**MATTERS FOR
LOCAL PLANNING PANEL
DETERMINATION**

Monday 30th April 2018

LIVERPOOL CITY COUNCIL
LOCAL PLANNING PANEL REPORT

Item no:	1
Application Number:	DA-593/2016
Proposed Development:	DEMOLITION OF THE EXISTING BUILDING AND CONSTRUCTION OF A FIVE (5) STOREY BOARDING HOUSE DEVELOPMENT CONTAINING NINETEEN (19) BOARDING ROOMS WITH GROUND FLOOR CAR PARKING AND ASSOCIATED LANDSCAPING
Property Address:	71 LACHLAN STREET, WARWICK FARM NSW 2170
Legal Description:	DP 249435 LOT 5 SEC 20
Applicant:	ACA DESIGN CONSULTANTS
Land Owner:	HAS HOS PTY LTD
Cost of Works:	\$2,797,880.00
Recommendation:	Refusal
Assessing Officer:	Boris Santana, Senior Development Planner

Figure 4: Extract of the floor plan that shows the extent of non-compliance with Building Setbacks on levels 2 - 4

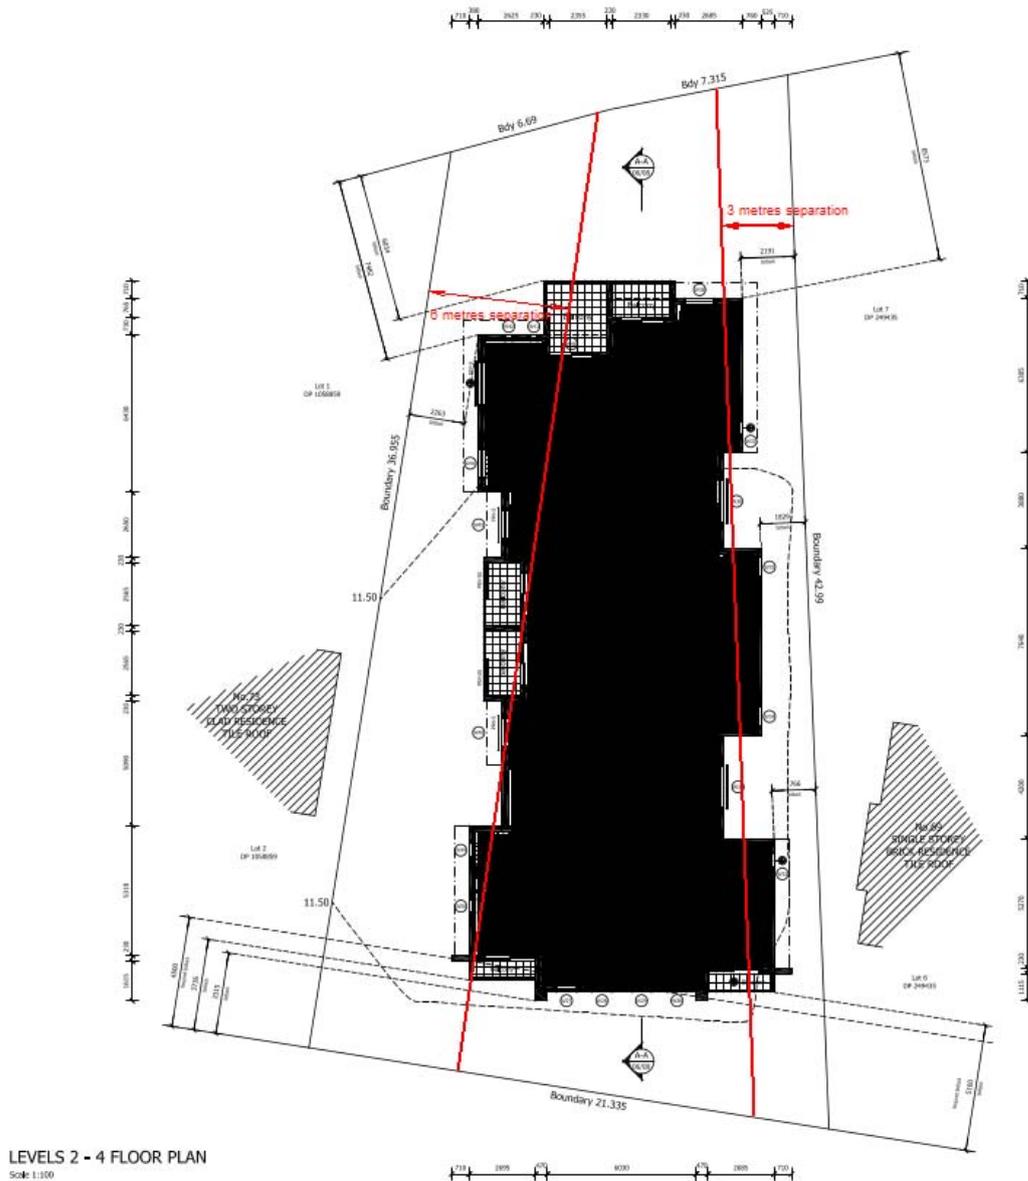
- Section 2.1 – Boundary Setbacks and Building, Part 4, of the LDCP 2008 requires that street frontage of any new building adjacent to heritage items is to be appropriately scaled. Lachlan Street is listed as a heritage item and the development is to be designed so that buildings relate to the heritage significance of heritage items – in this case the street grid. While the shape of the site is acknowledged as not being rectangular, the proposal does not provide appropriate building setbacks nor does the design generally reinforce the street alignment.

- 12 metres to 25 metres in height:
 - o 9m between habitable rooms/balconies;
 - o 4.5m between non-habitable rooms.

Figure 5: Extract of the floor plan that shows the extent of non-compliance with Building Setbacks on levels 5

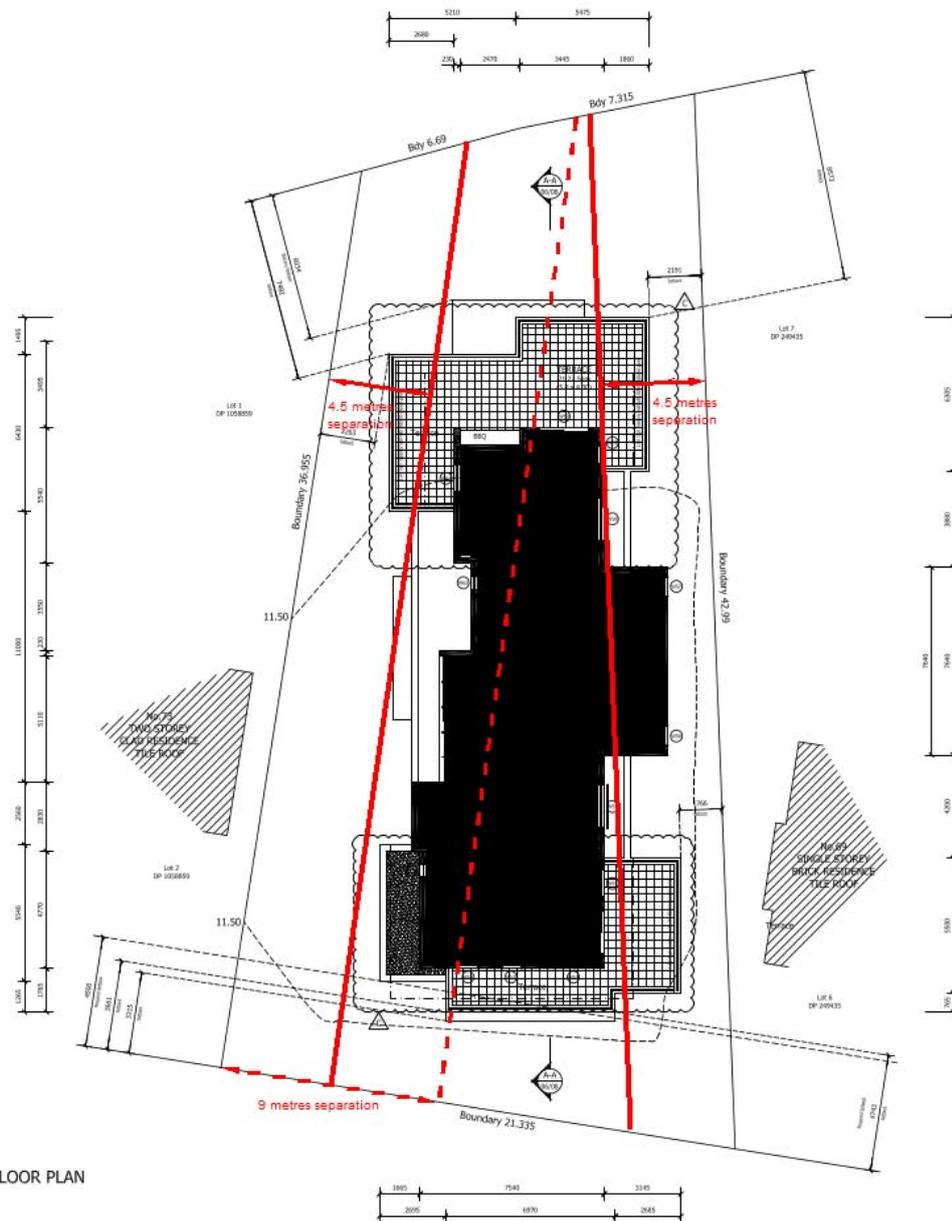
- Section 2.1 – Boundary Setbacks and Building and Section 5.5 Noise, Part 4, of the LDCP 2008 requires that buildings with a boundary to the Hume Highway are to be setback a minimum of 8 metres. With regards to Hume Highway, the development provides a setback ranging from 6.3 to 8.5 metres, of which the majority is below the required 8 metres.

Figure 11: Amendment to truck parking layout proposed to provide required separation to the electrical easement in the south-eastern corner of the site.

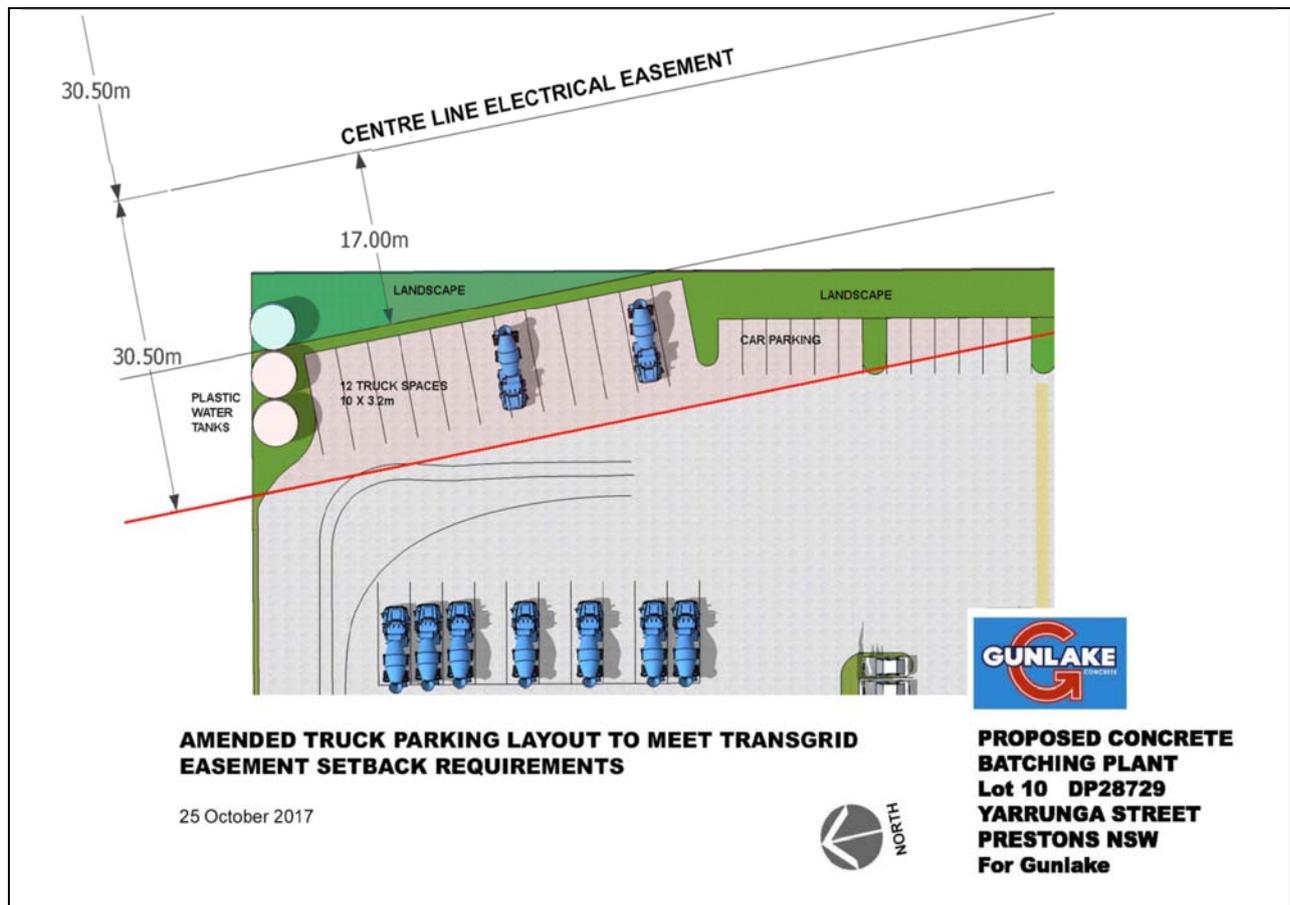
The applicant has provided an amended layout for truck parking in the bottom corner of the development site which is traversed by a high voltage electricity easement. The amended plan shown in Figure 11 below is endorsed by Transgrid which has advised that it has no objection to the proposed development subject to the attachment of conditions contained in the box below Figure 11.
